REQUEST FOR COUNCIL ACTION

AGENDA SECTION: PUBLIC HEARINGS	ORIGINATING DEPT: PLANNING	ITEM NO. E-8
ITEM DESCRIPTION: Final Plat #02-45 to be known as Harvestview		PREPARED BY: Brent Svenby, Planner

RE: Final Plat #02-45 by Bigelow Enterprises to be known as Harvestview. The Plat proposes to subdivide approximately 18.53 acres of land into 64 lots of which 62 lots are for single family attached dwellings, one lot is for common open space and one lot for a future commercial development and 4 outlots. The plat also dedicates the right of way for new public roadways. The property is located along the north side of 55th Street NW and along the west side of 50th Avenue NW.

HARVESTVIEW

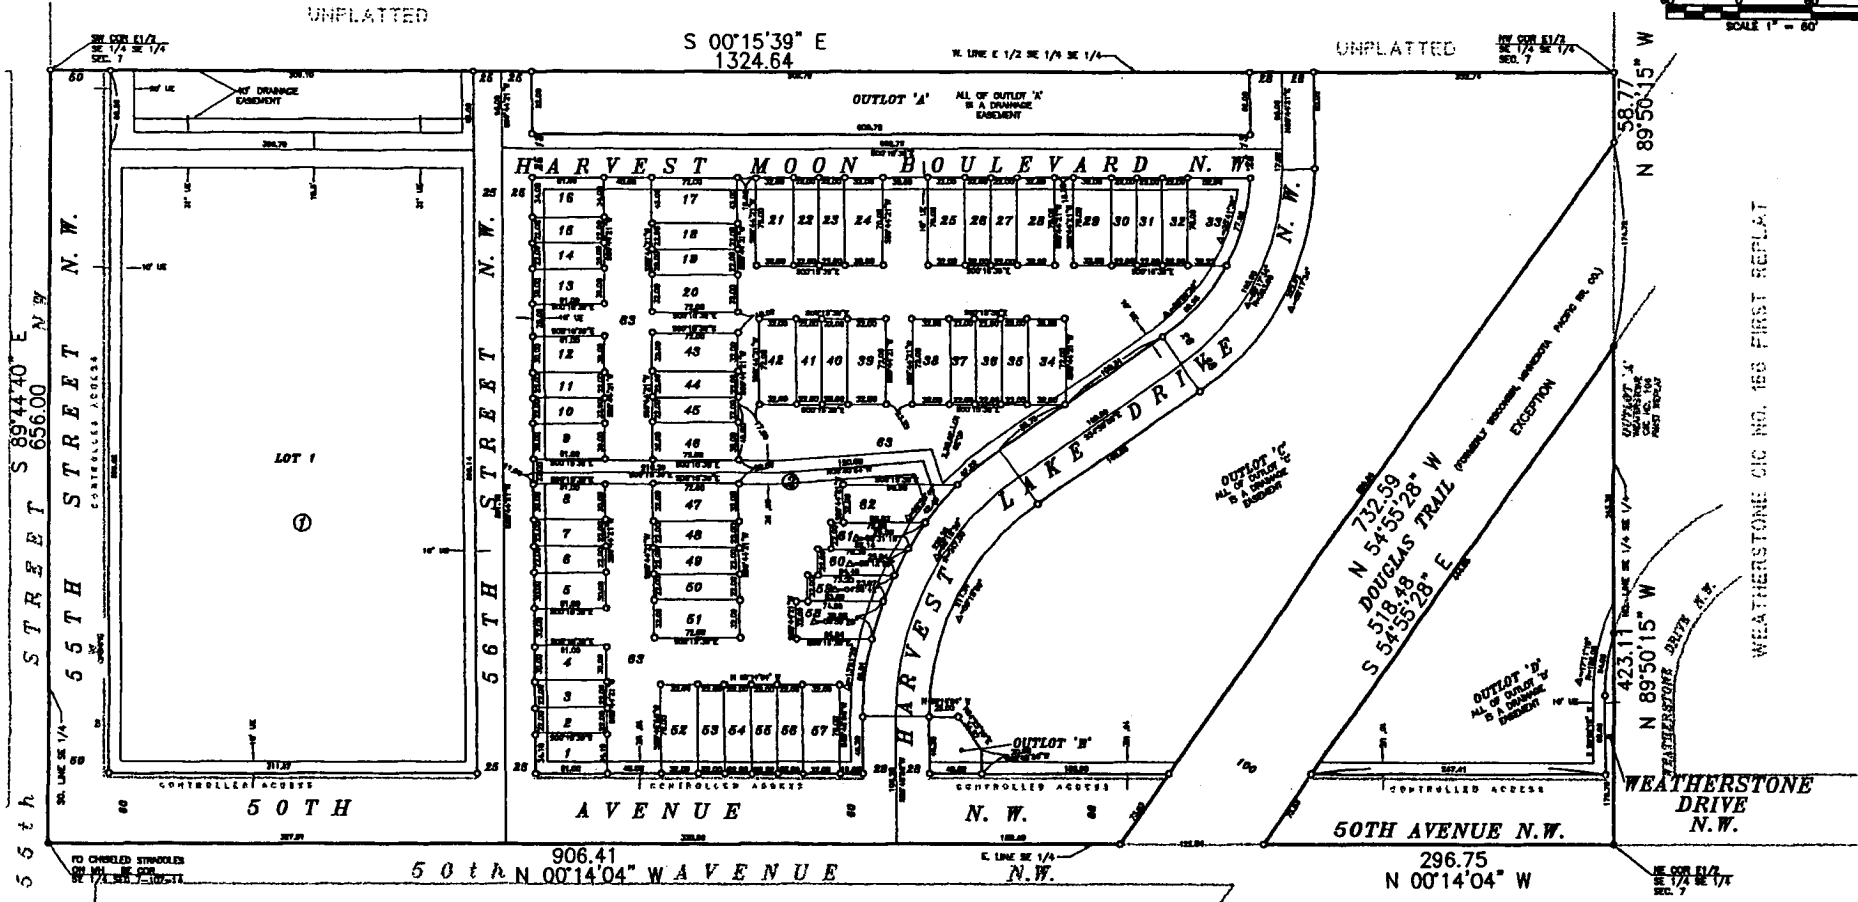
1. *Either 20' minimum utility easements or the entire Lot 63, Block 2 must be dedicated as a utility easement for the public water mains located within the block.*

2. *Prior to the recording of the final plat documents, the applicant shall dedicate the applicable easements required for off site drainage required for the development of this property.*

3. *No parking will be permitted on the south side of 56th St. NW from 50th Ave. NW to Harvest Moon Blvd NW and along the west side of Harvest Moon Blvd NW from 56th St. NW to Harvest Lake Drive NW.*

5. *The applicant shall dedicate Outlots A and C to the City.*
